SERVICE TECHNICAL INFORMATION

REF. NO. : SI-95-009
CUSTOMER RELATION & SERVICE DIV.

MODEL : AM-F1

SUBJECT : Method for replacing OWH (Over Write Head)

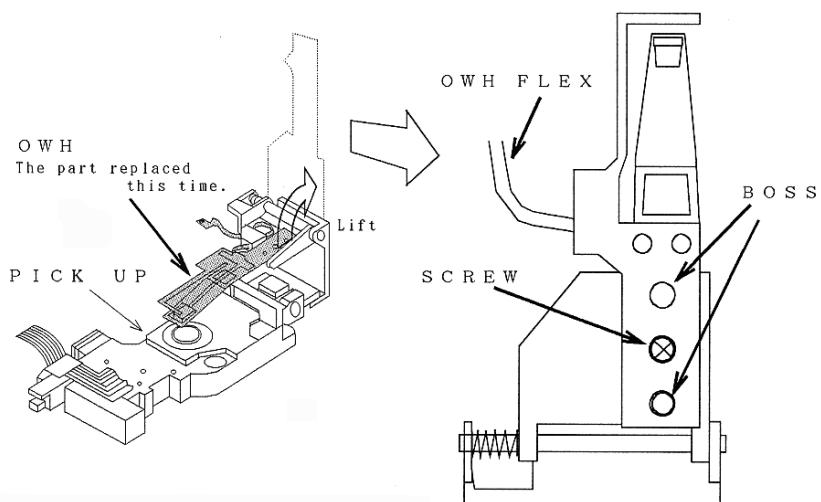
CONTENTS: Former information S1-95-002 instruct that the replacement of pick-up ass'y is strictly requested when even only the OWH is damaged.

However, after further examinations, replacement of OWH alone becomes possible by following method.

(Please do not remove parts other than the instructed points when you replace the OWH)

- (1) Disassemble the set so that the OWH replacement is able.
- (2) Disconnect the OWH flexible wire and raise the OWH then remove the screw located at middle of two bosses.

- (3) Remove defective OWH and put the new one into the bosses.
Confirm that the flexible wire of opposite side is not caught and temporarily screw.
(Be careful not to deform OWH)

- (4) Confirm that there is no slack between OWH and the base and tighten the screw.
- (5) Assemble the set and check the error rate for record/playback using the test mode.
(Please refer to the service manual)
At this error rate check, please put the DSL SW to 1 and use 100 clusters between 600 to 700 clusters.
For the confirmation of error rate after record playback (2) : 2), press DISP KEY after 600 clusters passed.
Also the error rate is displayed even 1 count, try it again with another disc.
If the error rate is usually counted, provably the installation of OWH is wrong or another faults causes it.
